The Town of Hilton Head Island Regular Design Review Board Meeting

DESIGN TEAM/ DRB COMMENT SHEET

PROJECT South Island PSD

DRB# DR100022

PLANTING PLAN

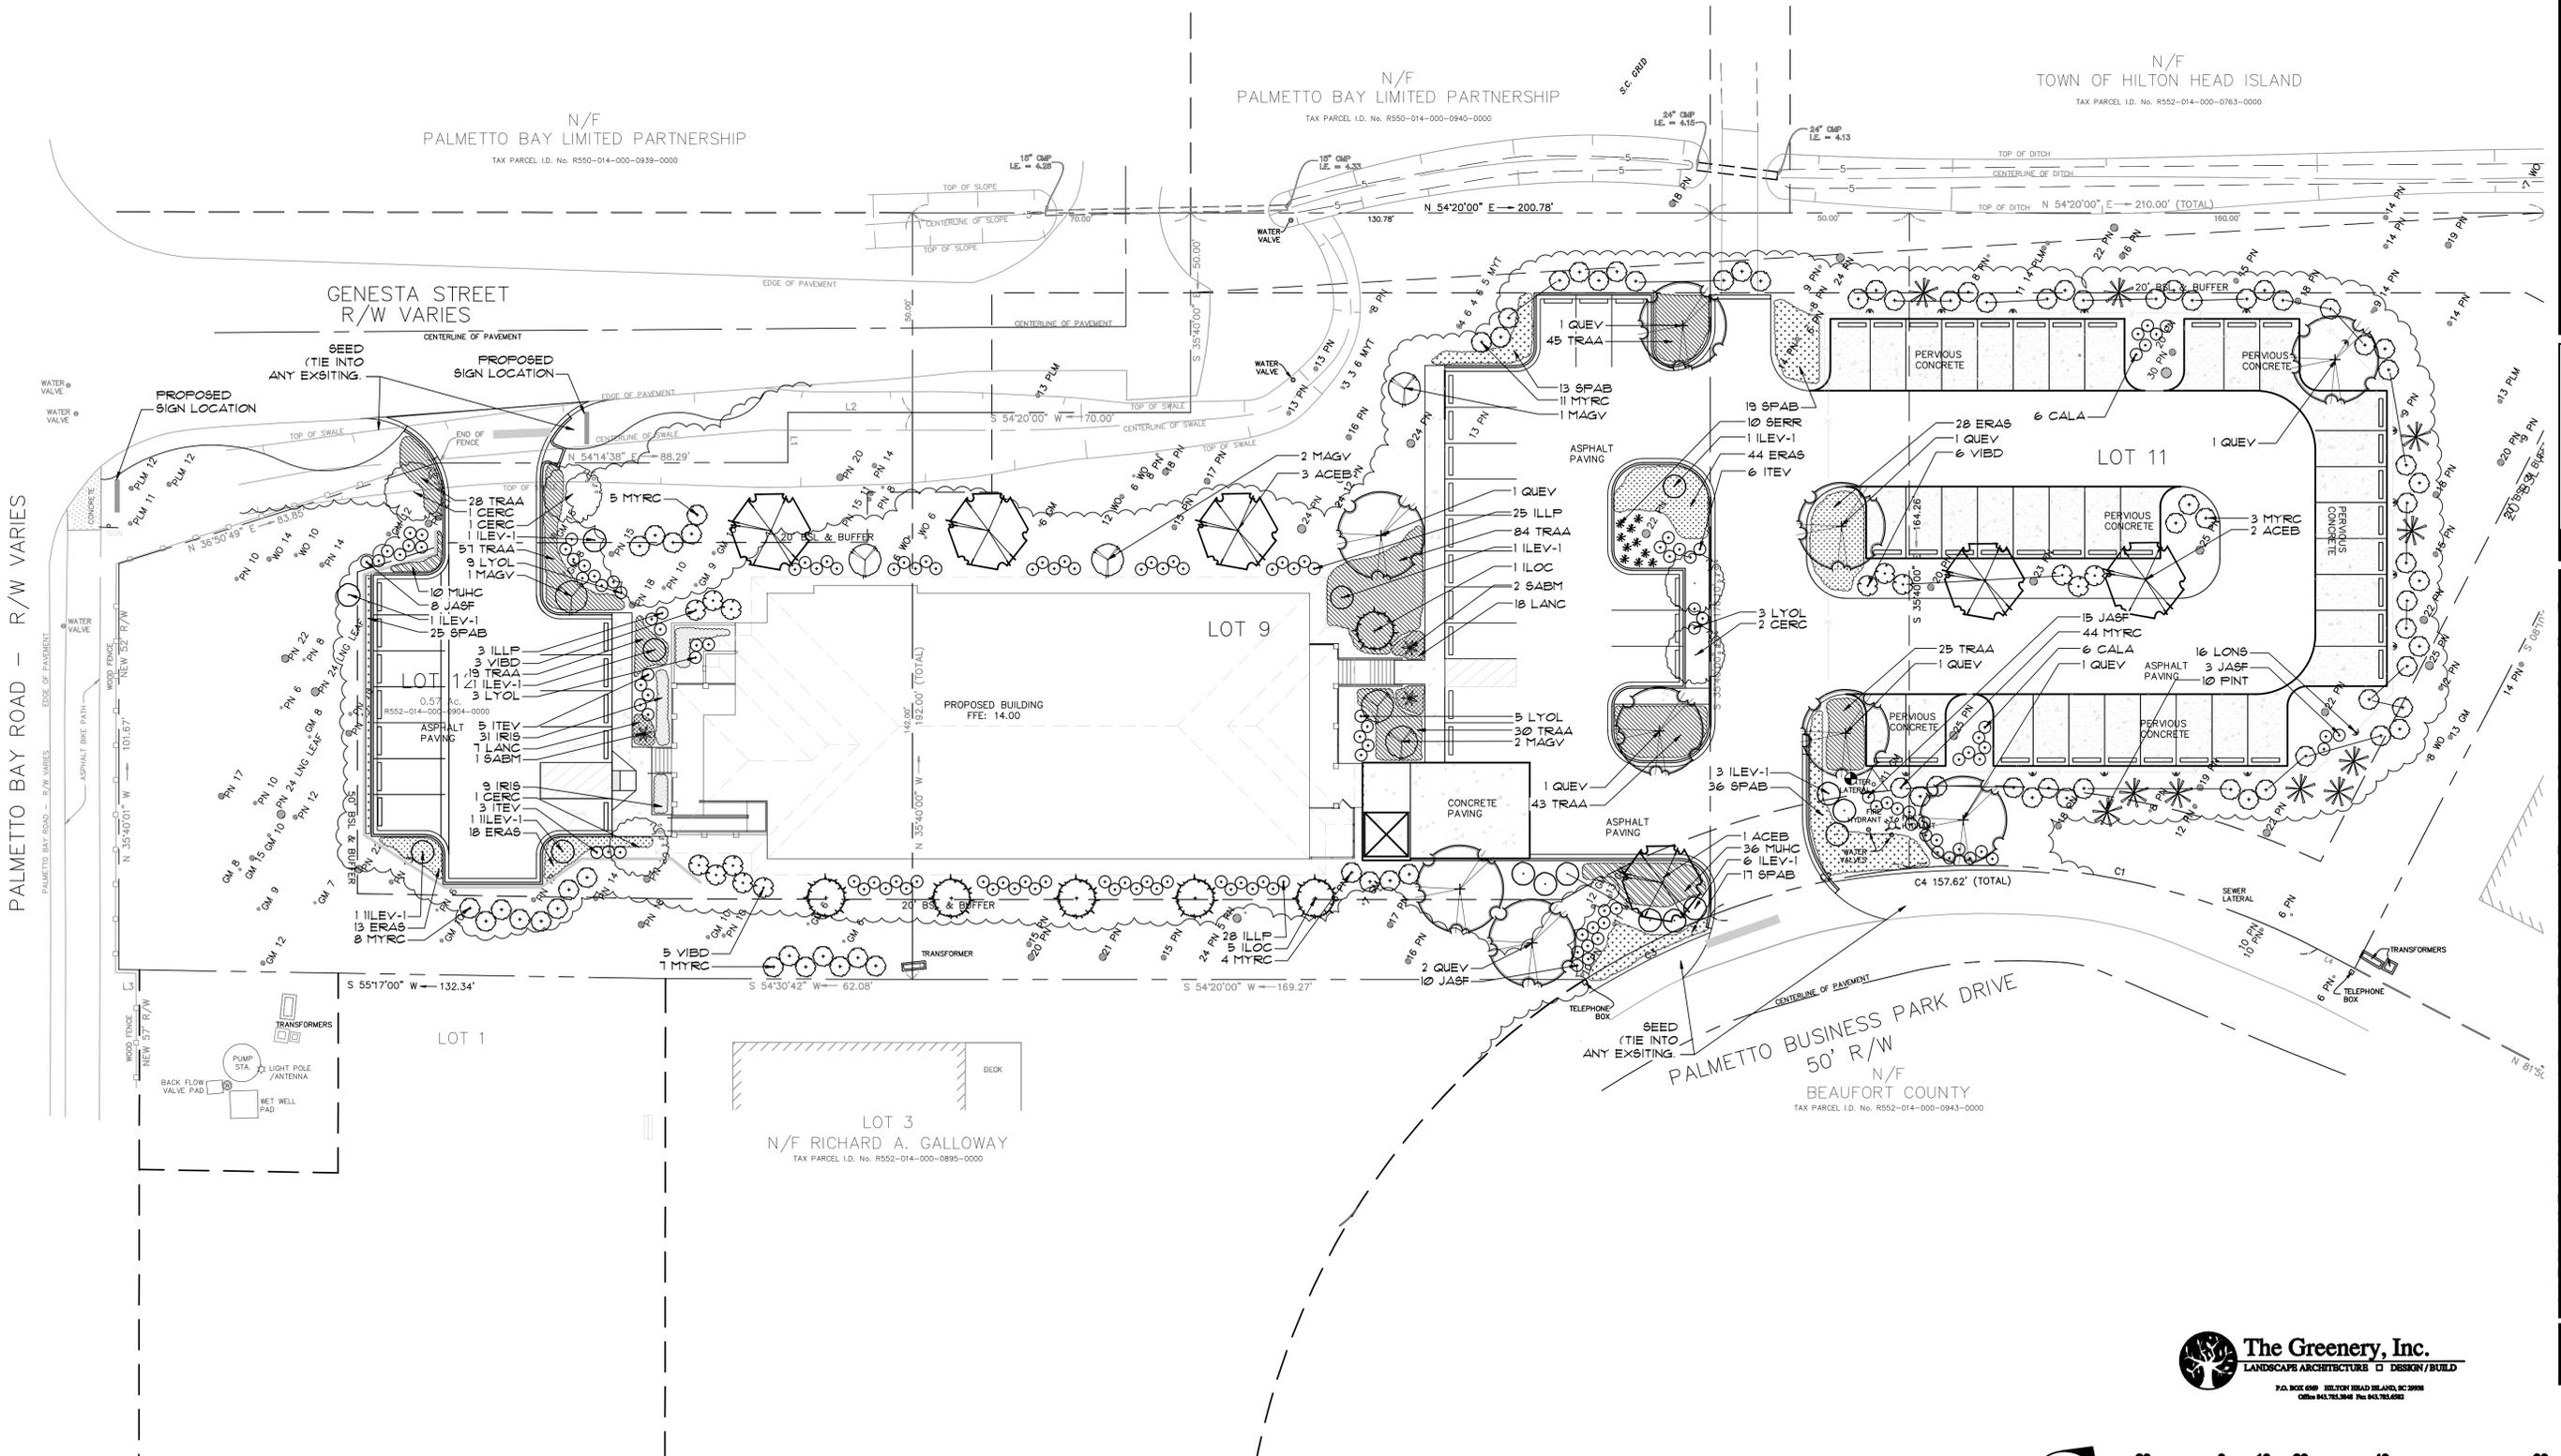
DESIGN GUIDE/LMO CRITERIA	COMPLIES YES/NO/NA	COMMENTS OR CONDITIONS
An effort has been made to preserve existing trees and under story plants		Florida maples are not found on HHI---substitute Red maples (Acer rubrum) Sweetbay magnolias do not do well on the island; substitute Loblolly Bay.
Supplemental and replacement trees meet LMO requirements for size, species and number		
Wetlands if present are avoided and the required buffers are maintained		
Sand dunes if present are not disturbed

DATE
 June 29, 2010
 PROJECT NUMBER
 01-10014
 SHEET TITLE
 SITE PLAN

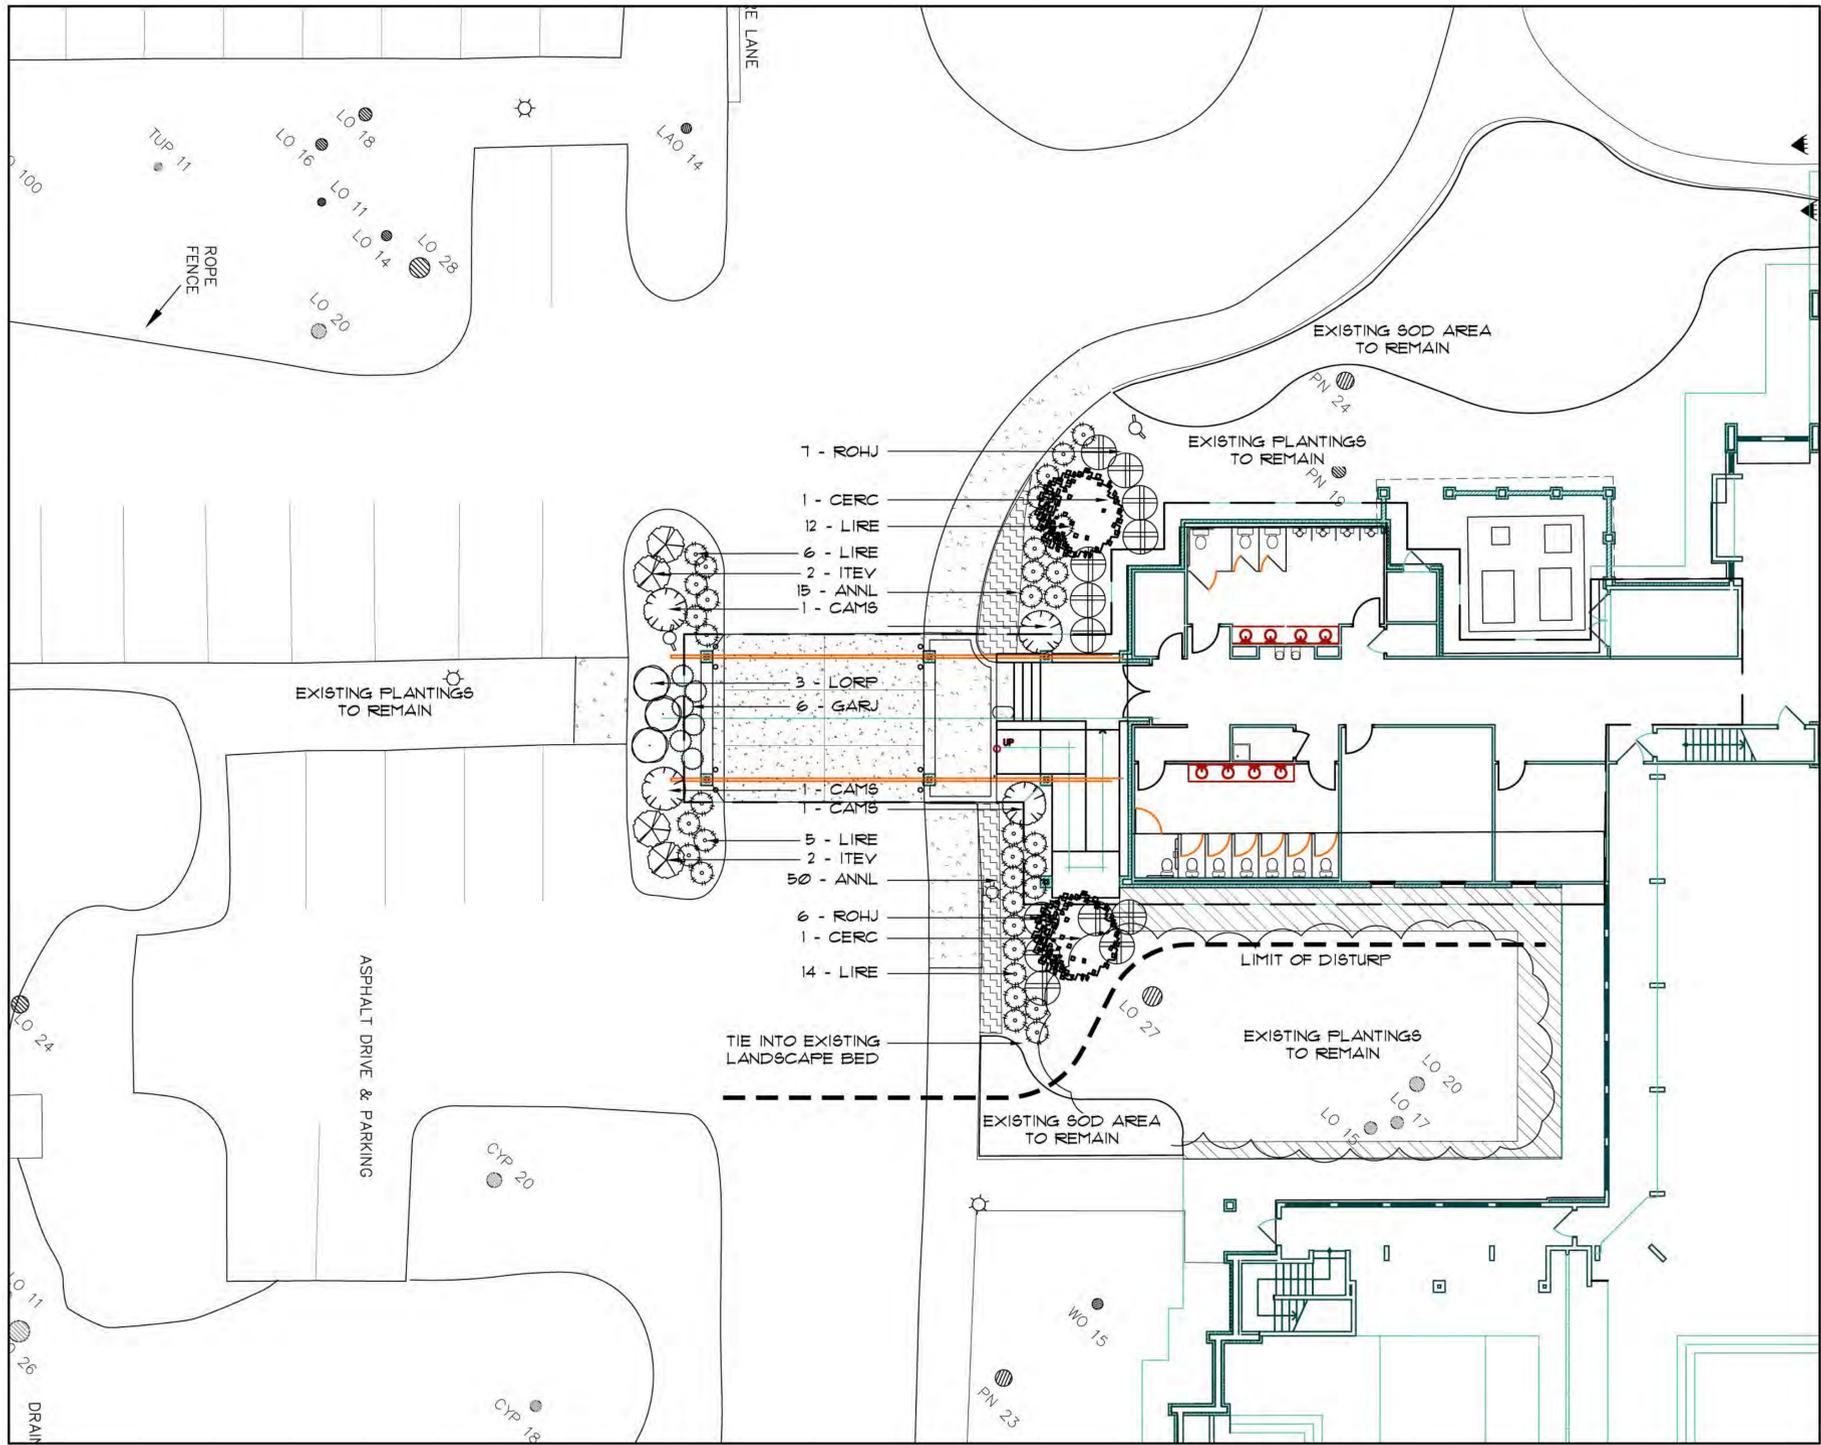
DESIGN GUIDE/LMO CRITERIA	COMPLIES YES/NO/NA	COMMENTS OR CONDITIONS
An effort has been made to preserve existing trees and under story plants		To decrease impacts to root system of 27 inch live oak, remove three RODH nearest tree.
Supplemental and replacement trees meet LMO requirements for size, species and number		
Wetlands if present are avoided and the required buffers are maintained		
Sand dunes if present are not disturbed
